BURLINGTON DEVELOPMENT REVIEW BOARD

To: Development Review Board
From: Mary O'Neil, AICP,
Principal Planner
Date: August 2, 2016
RE: ZP16-1506CA/CU 0
University Road / 290 East
Avenue

Request: Construction of a new 1 story building for UVM Rescue Services. Sidewalk and parking reconfiguration, no change in the overall number of parking spaces.

OVERALL
SITE
PLAN

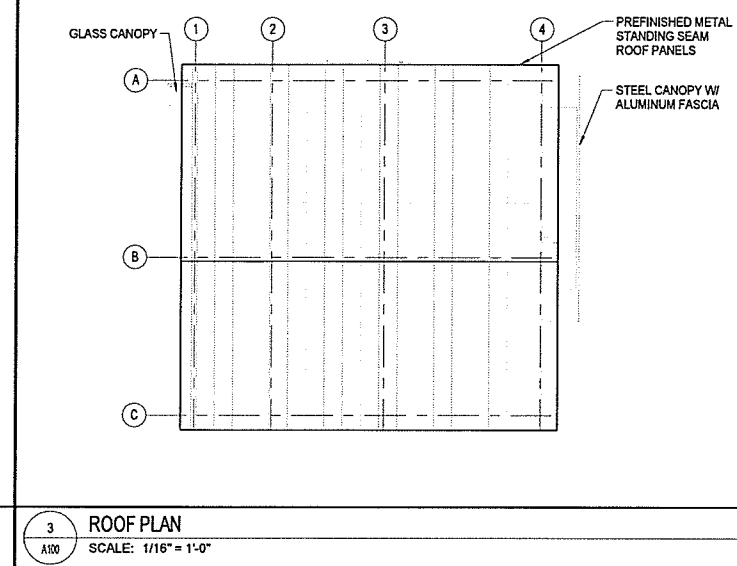
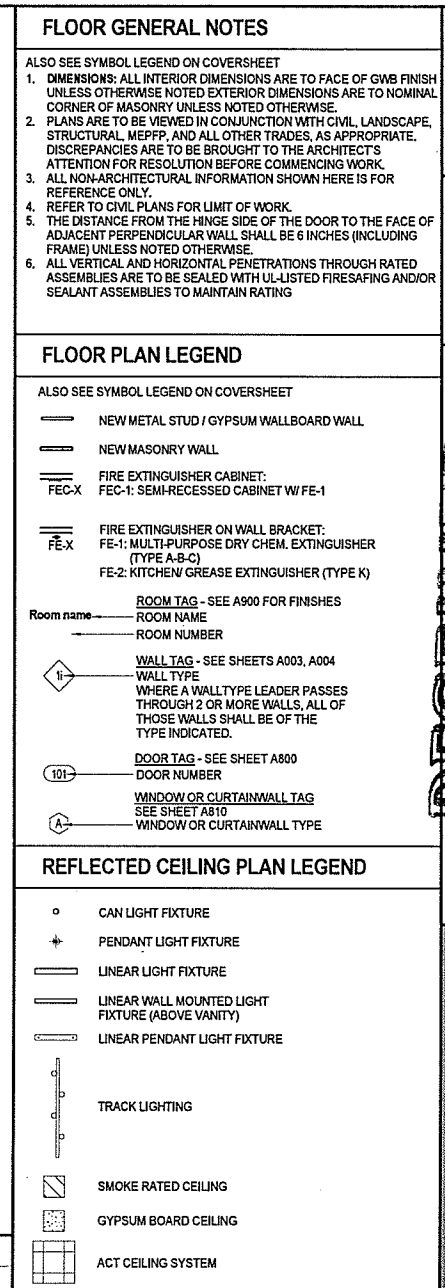
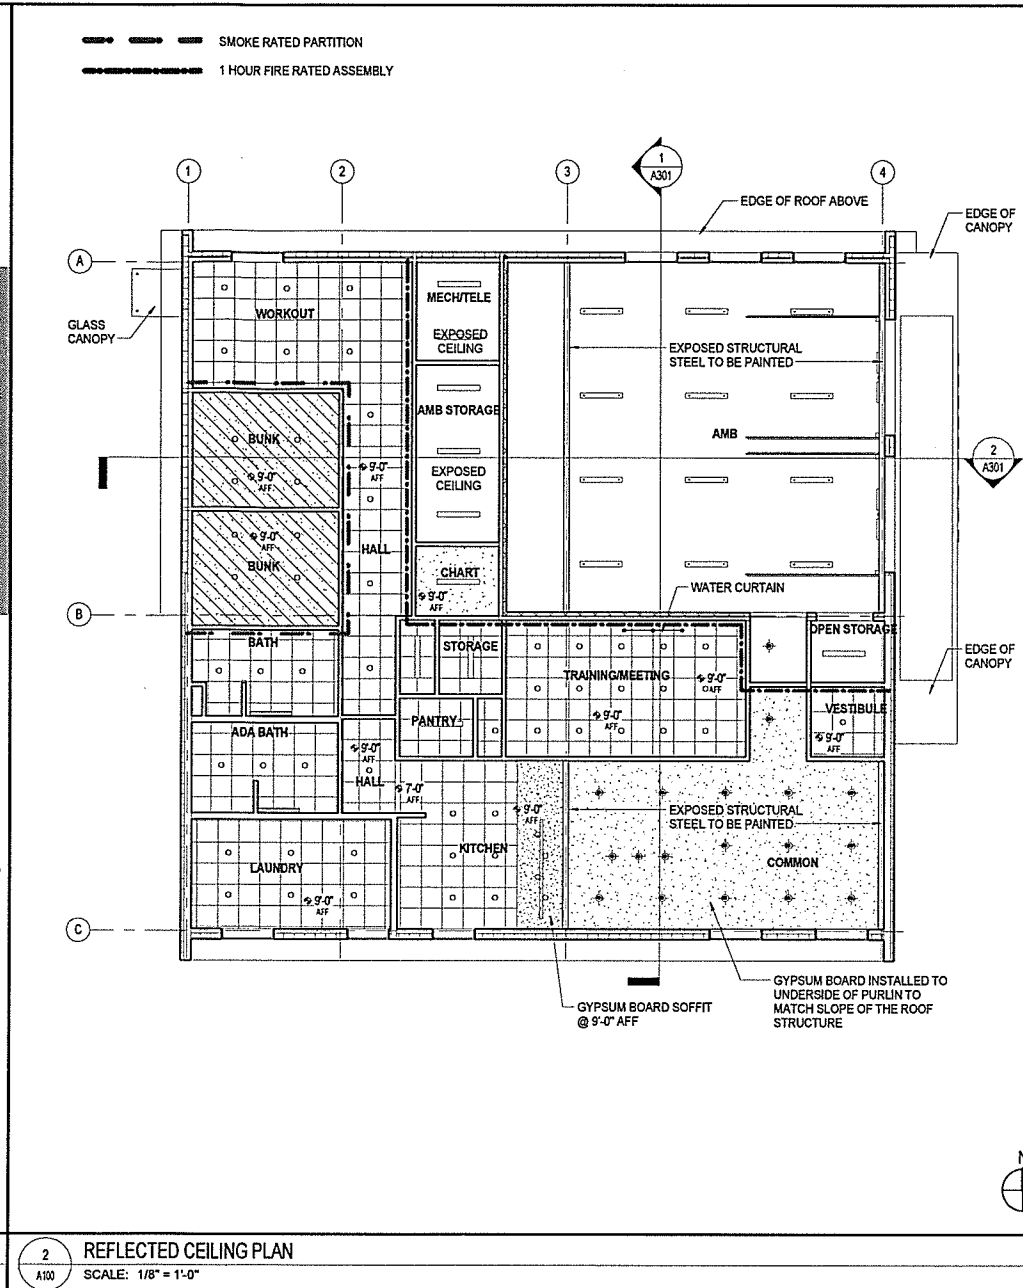
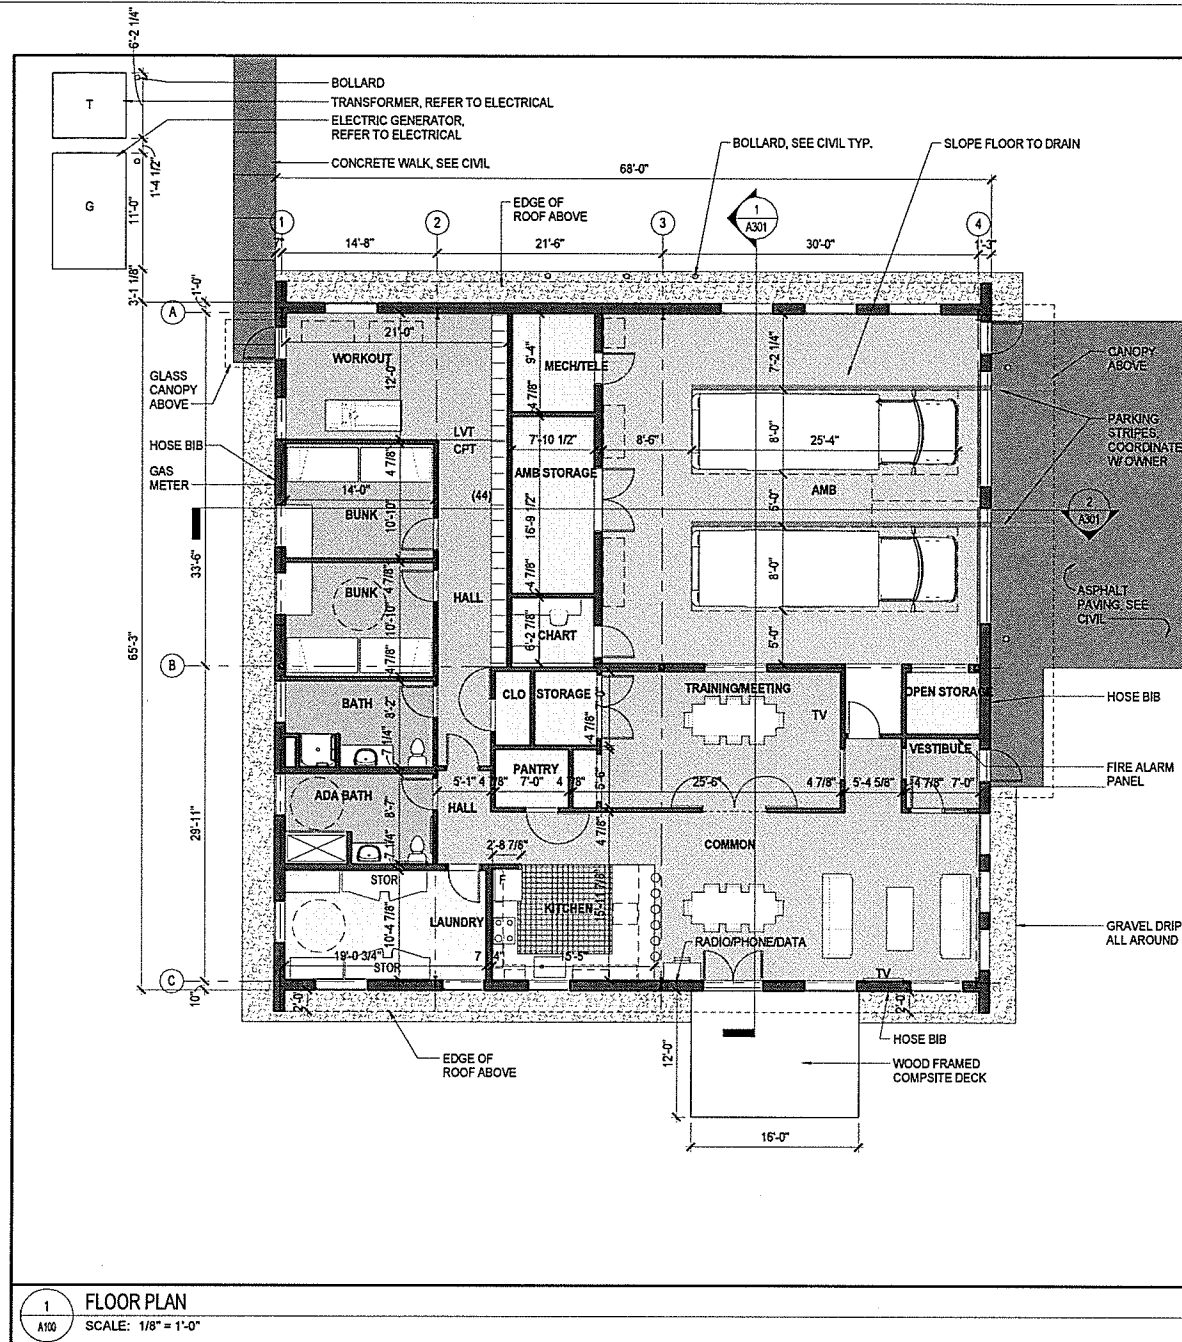
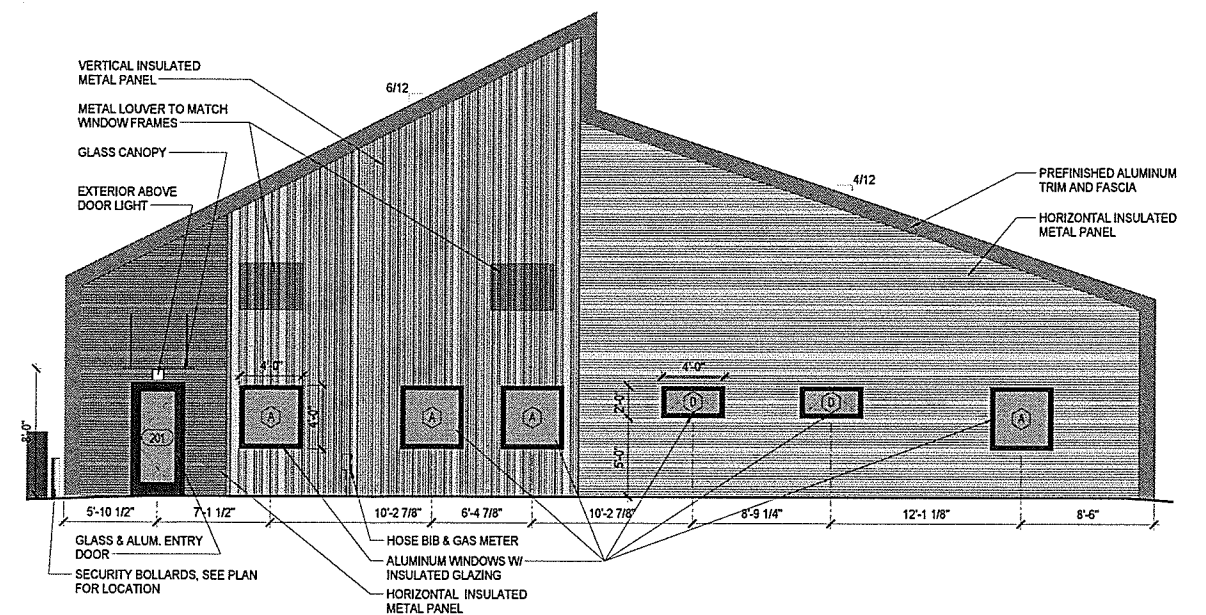
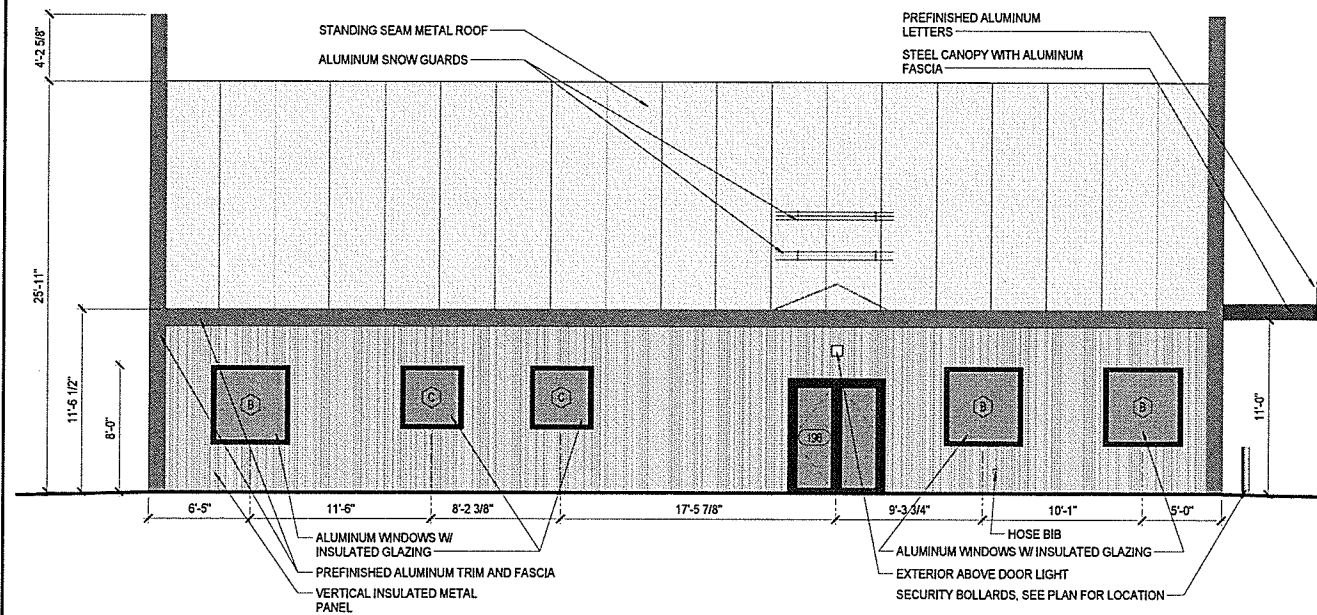
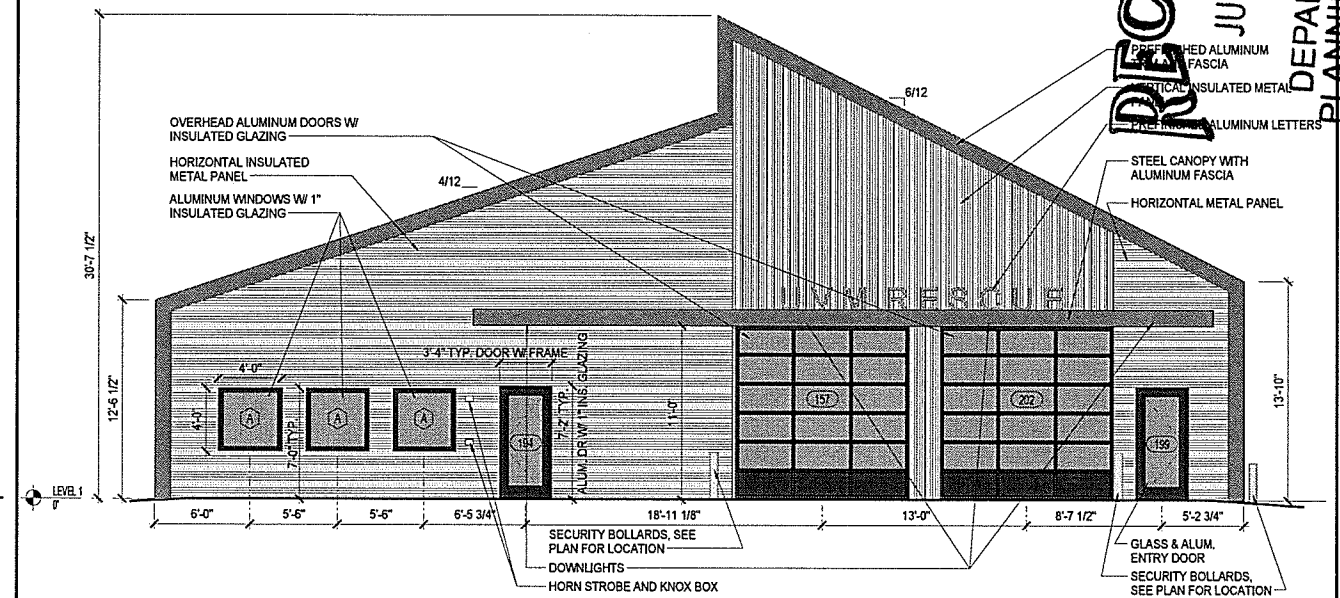
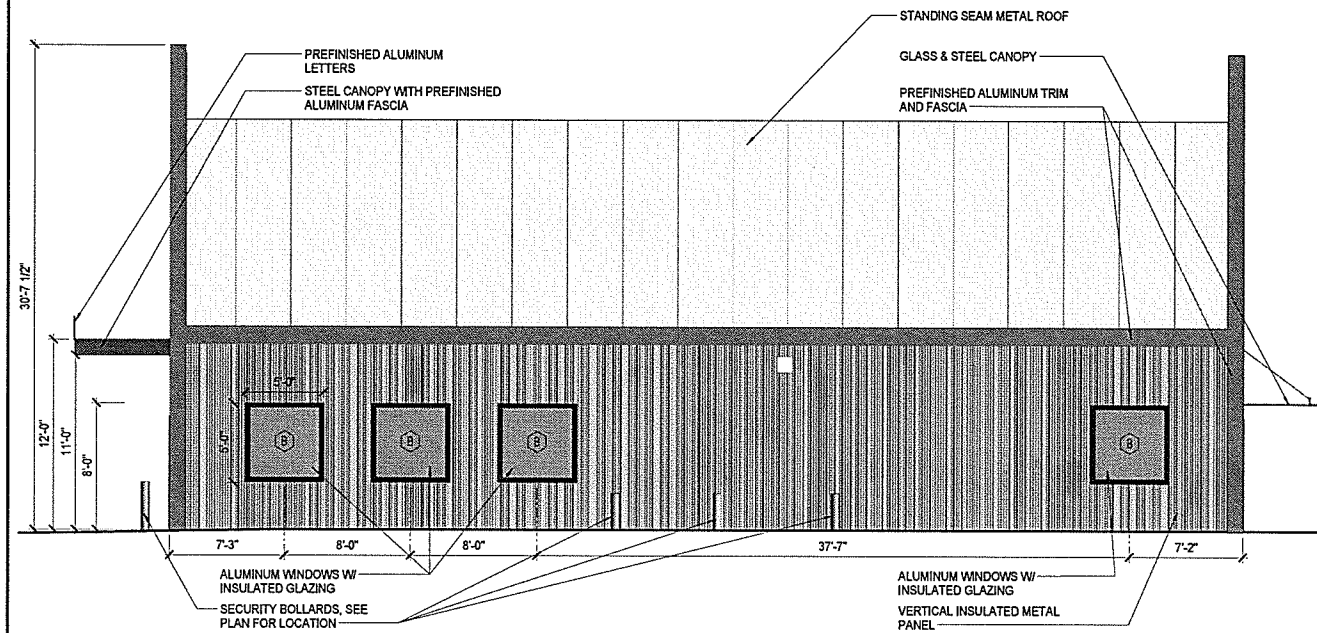
A pedestrian connection from the 284 East Avenue complex is illustrated on the FFF aerial image looking southwest; this pedestrian path is not evident on the site plan SP-1 and needs to be. A crosswalk is evident, but not uninterrupted and protected pedestrian path from the existing police services building. It may make sense to relocate the crosswalk to align with the landscaped island, to connect directly to the pedestrian door adjacent to the ambulance bays on the east elevation. Otherwise, a pedestrian path needs to be identified on the site plan to clearly articulate a separate between vehicles and pedestrian traffic. **Affirmative finding as conditioned.**

Vehicular circulation is proposed to utilize the existing private roadway from 284 East Avenue. No change to the current parking count is proposed, which is contrary to reporting within the most recently adopted Joint Institutional Parking Management Plan which suggested a net decrease in spaces for this anticipated project. (See 2014-2019 Campus Area Transportation Management Association Joint Institutional Parking Management Plan, p. 4-4, Table 21.) The Freeman French Freeman illustration shows new parking in front (east) of

the building as well as parallel parking spaces along the private roadway. The applicant has directed that this was for illustrative purposes only; the site plan offers the accurate parking space configuration and count. **Affirmative finding.**

New pines are proposed for both the west and east of the site. Additionally, arborvitaes are illustrated on the site plan to screen a generator. As submitted, landscaping and screening are satisfactory. **Affirmative finding.**

5. It is the responsibility of the applicant to secure all applicable local and state permits, include a state stormwater permit.
6. A clearly articulated separation between vehicles and pedestrian pathways will be required on the site plan. This revision to be site plan is subject to staff review and approval.

7. All building and life safety code, including accessibility guidelines will be observed as defined by the building inspector and fire marshal.
8. Approval of this plan includes tree removal and replacement with new landscaping as defined on plan SP-1.
